**Re: Picasso RV - 7800 Jacs Ln. NE
Grading & Drainage Plan Engineer's Stamp Dated 12/29/2017
(D16D002A6)**

**Re: Picasso RV - 7800 Jacs Ln. NE
Grading & Drainage Plan Engineer's Stamp Dated 11/21/2017
(D16D002A6)**

Based upon the information provided in the submittal received on 11/27/17 the above-referenced plan cannot be approved for Building Permit and/or Grading Permit until the following comments are addressed.

SECTION C-C
NTS

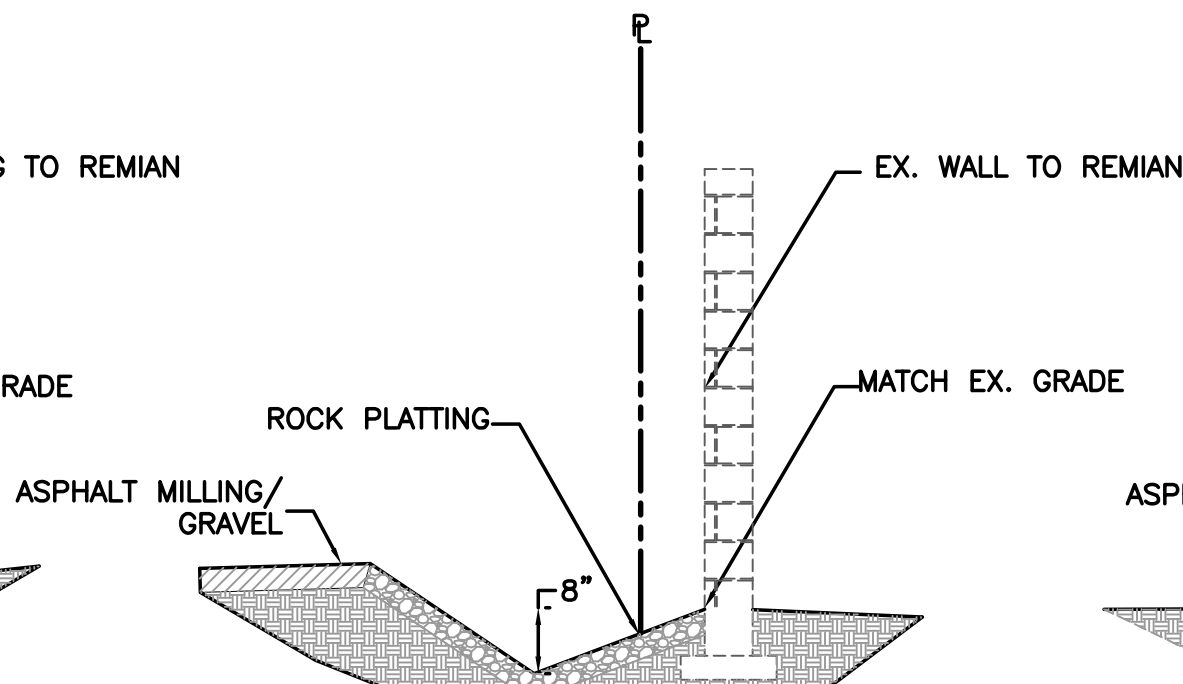
3. Similarly the hydraulic capacity calculations of the swale in section C-C should either be revised in the report to match the geometry of the section on the G&D Plan or the revised calculations can be shown on the G&D Plan next to the section. The detail and the calculations should agree. **We updated channel capacity**

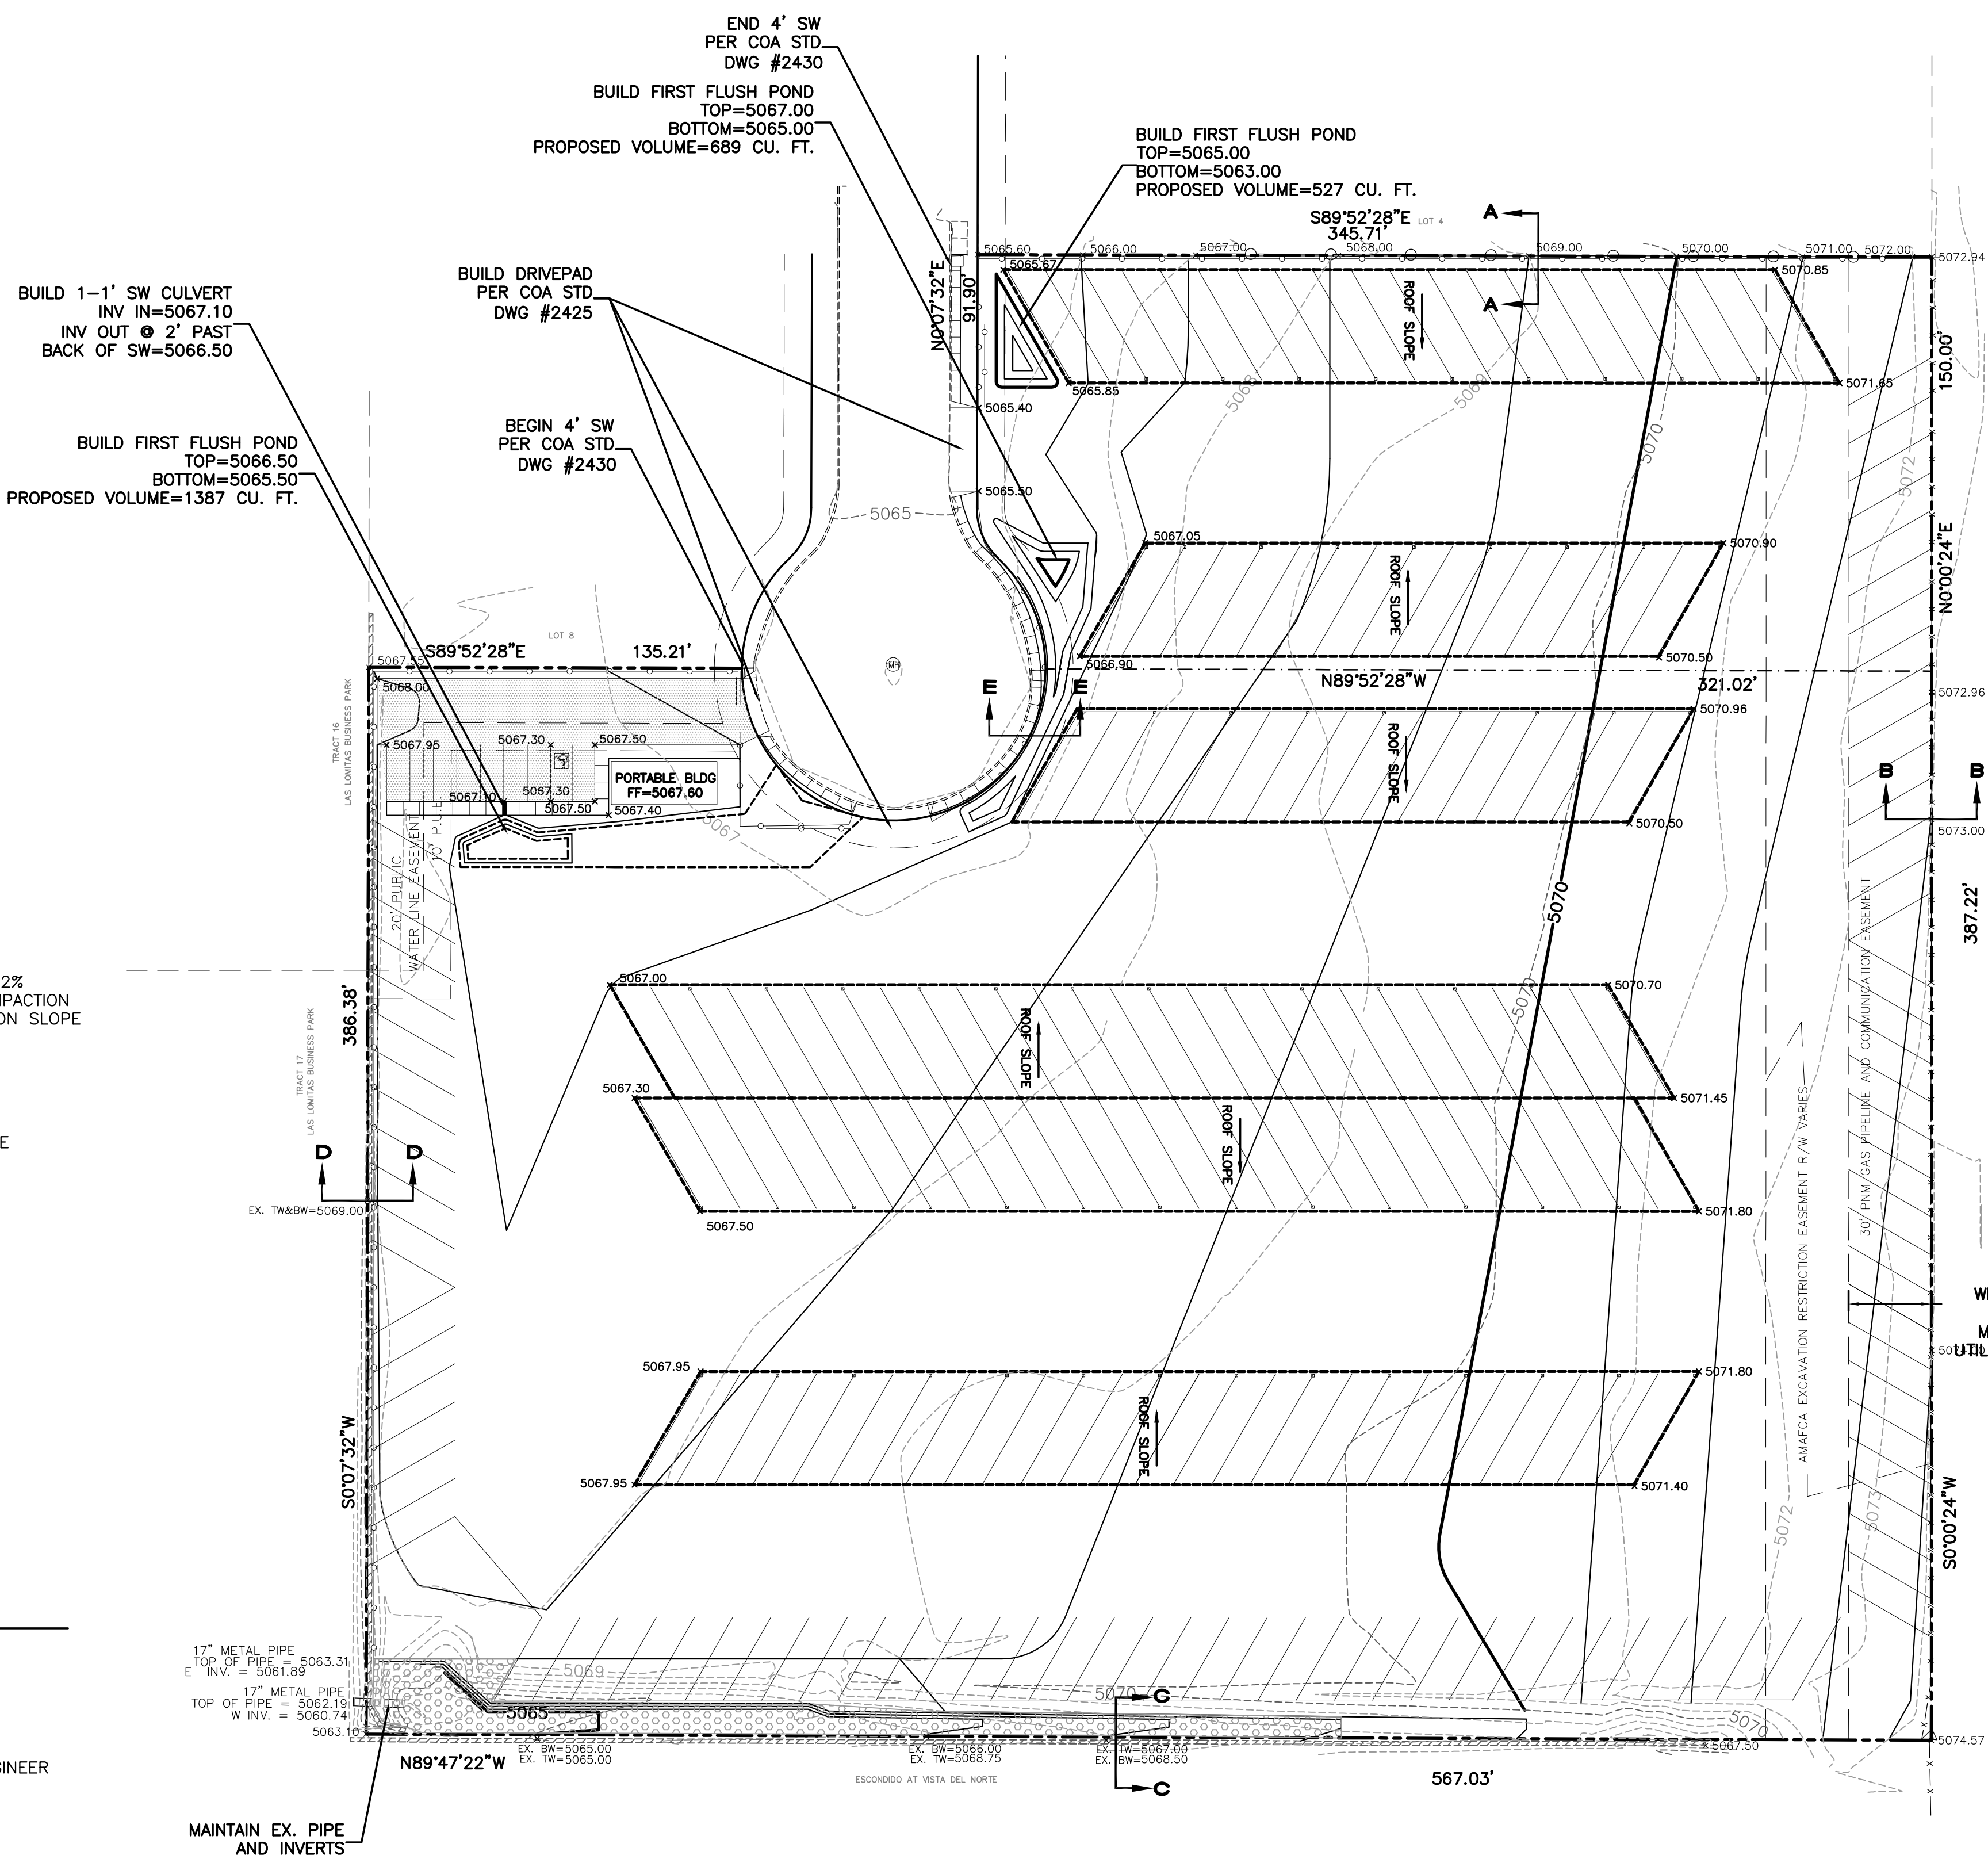
1. Flow arrows and spot elevations should be added showing the onsite swale next to Jacs Ln. that will divert onsite drainage into the ponds before it enters the public right of way. **We have adjusted contours and added arrows and spots**

2. A typical section showing the horizontal and vertical dimensions from the right of way line of Jacs Ln. to the curb and gutter, sidewalk, and onsite drainage swale should be shown on the G&D Plan. Hydraulic capacity calculations should be shown next to the section of the onsite swale. **We expanded pond and added xsec**

4. Please add a big caution note in the vicinity of the existing 30' PNM Gas Pipeline and Communication easement on the east side of this property. **Added**

5. Written approval of this plan is required from PNM **only fill placed, pending nm gas***
6. This work requires an ESC plan to be submitted to the storm water quality engineer (Curtis Cherne, PE ccherne@cabq.gov) prior to Grading Permit approval. **Obtained**

*** We have requested written authorization but not yet recieved. The plan does not have any Cut in the area of easement**
